Notification Response

Development Application DA2025/0263

**Alterations and additions to a dwelling house including a new swimming pool
16 Hillcrest Avenue, Mona Vale**

Figure 1 – Extract from submitted section showing relationship of proposed pool to the rear boundary and our clients secondary dwelling.

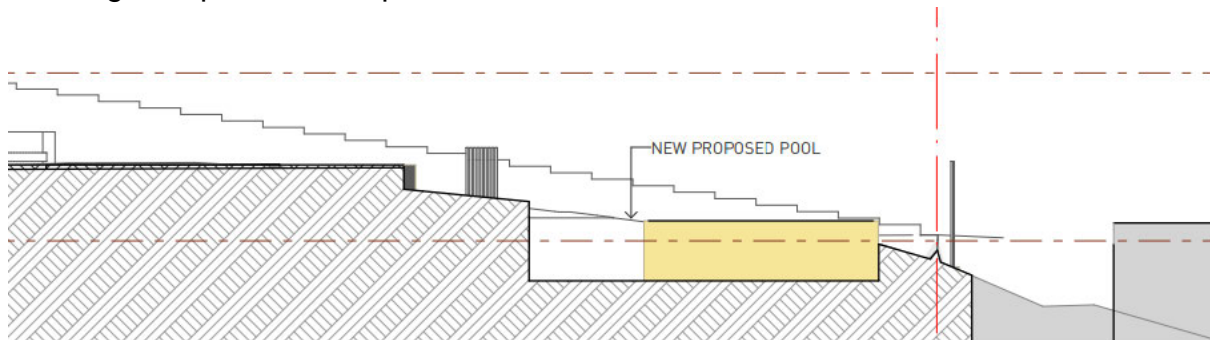
There is a general absence of detail in relation to the finished RL's of the proposed swimming pool and its immediate surrounds relative to existing ground levels adjacent to the rear boundary of the property which immediately adjoins our clients secondary dwelling. It is assumed that the pool coping will have an RL of approximately RL 53.6 which places it approximately 1m above the top of the retaining wall located on our client's property the height of which establishes ground levels along the common boundary.

The architectural plans also failed to nominate proposed setbacks of the swimming pool and coping/ surround to the side and rear boundaries of the property either in plan or section. The relationship of the swimming pool to our client's secondary dwelling is depicted in the plan extract below.

In our opinion, the location and height of the proposed swimming pool relative to our client's secondary dwelling and east facing private open space prevents the provision of appropriate landscaping within the side and rear boundary setbacks to prevent direct and immediate overlooking from the swimming pool and associated coping/decking into the east facing private open space area of our client's secondary dwelling.

In this regard, the landscaping nominated within the rear setback has mature heights of between 1 and 2 metres which given the elevated nature of the swimming pool relative to the finished ground level at the boundary will have an effective height of 1m above pool coping level and therefore provide no privacy attenuation whatsoever.

In circumstances where the proposed boundary fencing in this location is a 1.8m high open metal palisade fence through which direct and immediate views will be obtained into our client's property we are of the opinion that Council cannot be satisfied that satisfactory landscaping within the setback from the pool coping to the rear of side boundary is achieved being a precursor to a relaxation/ variation to the 6.5m rear setback control.

Further, Council cannot be satisfied that the height and location of the swimming pool relative to the rear boundary of the property will not give rise to adverse visual and aural privacy impacts to our client's secondary dwelling both in terms of direct and immediate overlooking into the east facing secondary dwelling private open space but also acoustic impacts associated with the use of the swimming pool immediately adjacent to the bedroom of the secondary dwelling. Council cannot be satisfied that the amenity of our client's property will not be affected by the rear boundary setback proposed being a precursor to a relaxation/ variation to the 6.5m rear setback control.

Under such circumstances the proposed swimming pool does not satisfy the rear boundary setback variation provisions and accordingly strict compliance with the 6.5m rear setback control should be enforced with existing ground levels at the rear of the site maintained.

Figure 2 – Extract from approved secondary dwelling plan submitted section showing relationship of proposed pool coping level to the rear boundary and our clients secondary dwelling.

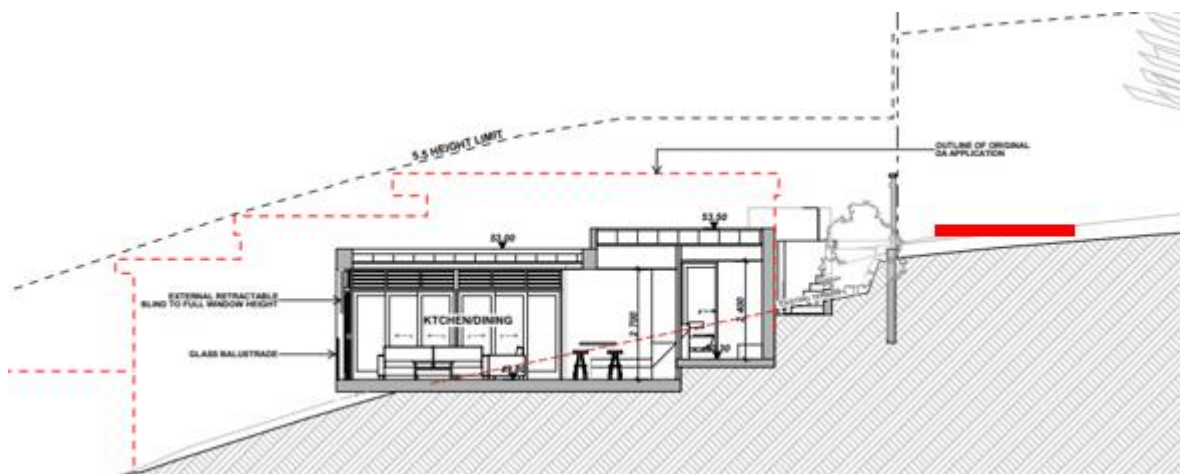
Additionally, the finish height of the pool coping is substantially more than 1m above the finished ground level of our client's property as depicted in the section extract below with the proposed swimming pool coping level depicted by red line.

Council cannot be satisfied that the intent of the consideration that swimming pools not be more than 1m above ground level (existing) given the immediate and overbearing height of the swimming pool relative to our client secondary dwelling and the direct and immediate overlooking opportunities it affords is satisfied being a precursor to a relaxation/ variation to the 6.5m rear setback control. The spatial and visual relationship of the swimming pool to our client secondary dwelling is depicted in the following image.

Figure 4 – Extract from submitted plans showing unnecessary secondary elevated access stairs within the front setback.

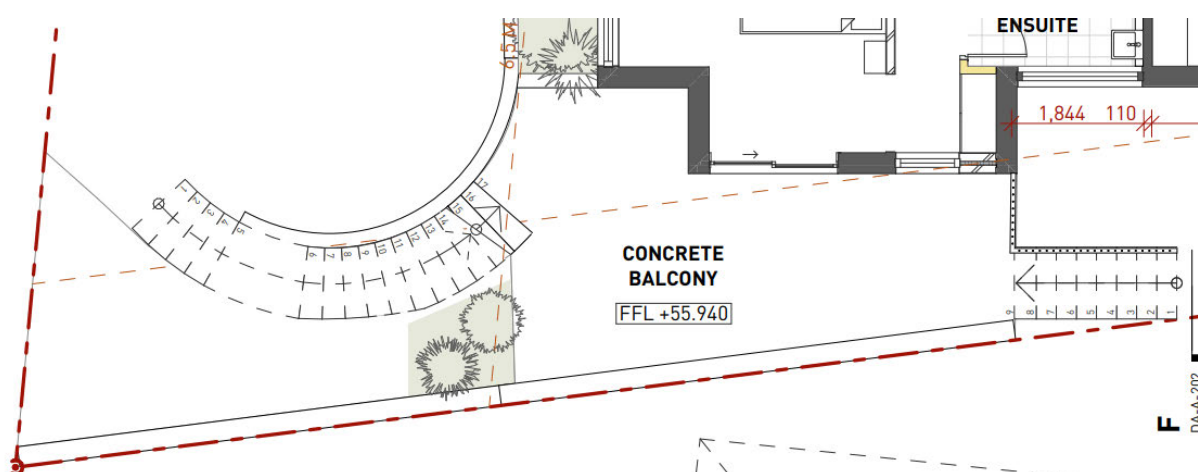
The proposal introduces two (2) pedestrian access stair structures within the 6.5m front building line setback with the western stair structure providing access to the formal entrance to the dwelling generally in the location of the existing access stair structure.

The proposal also introduces an eastern elevated stair structure providing access to a terrace area adjacent to bedroom 3. This second access structure is unnecessary and unreasonably reduces the landscape opportunity within the front setback area of the dwelling and immediately adjacent to our client's property. We request that this secondary access stair be deleted and replaced with landscaping and that a 1.8 m high privacy screen be constructed along the eastern edge of the concrete balcony adjacent to bed 3 to maintain appropriate visual privacy to our clients proposed dwelling entrance. This secondary access structure is depicted in the plan extract below.

For the reasons outlined in this submission we have formed the considered opinion that the application must fail in its current form unless the secondary front access stairs are deleted and the proposed swimming pool setback 6.5m from the rear boundary the property.
